## FCO Application

**Field Change Order Number:** DS-ZXHX6-XX-F001

**Applicability:** Prioris ZX6 and HX6 Models;

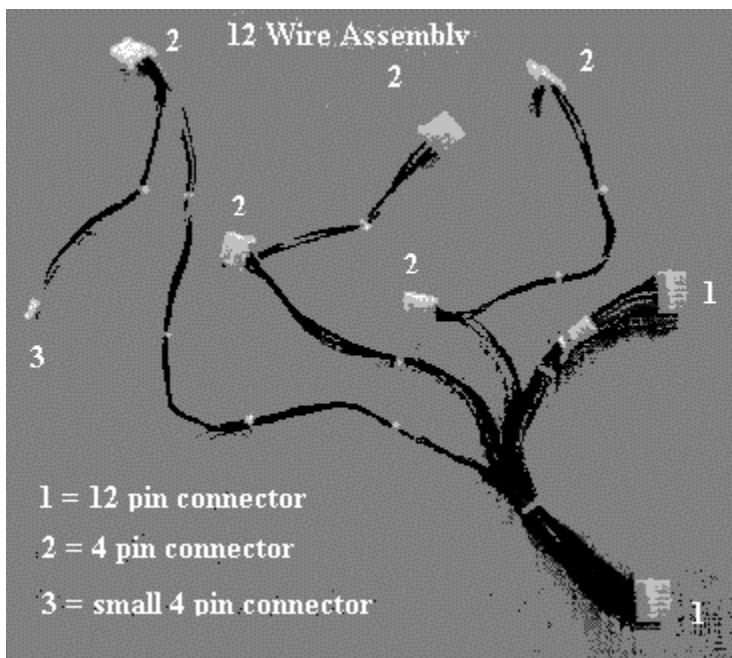
**Problem Statement: The problem is with a lot of Power Harness cables from the Power Supply to the SCSI Backplane on the HX6 and ZX6 systems.**

We have information from the cable manufacturer, Amphenol, indicating that in **Oct.Nov.Dec.1996** and possibly **Jan.1997** they used Molex contacts in connector housings manufactured by JM for the 12 pin power connectors (P1;P2) .The Molex contact becomes distorted when inserted into the JM connector and can cause intermittent connection when plugged into the power supply, this has been substantiated by Field data. Defective Date codes for cables manufactured during this period are **4496 to 1397. The manufacturer's name is Amphenol.**

- 4) Unlock and remove the server side panels.
- 5) Locate the 12-wire cable assembly (P/N 70-31894-01) that is connected to the power supplies, SCSI backplane, diskette drive, and any optional drives (e.g. CD-ROM drive, tape drive, etc.). See item 7 below in Figure 13-3.

manufacturer be examined. **This is an as needed FCO.** Any systems found with power harness manufactured by Amphenol with a 4496 to 1397 date code should be replaced.

**Procedure for Replacing the 12 Wire Cable Assembly (P/N 70-31894-01)**
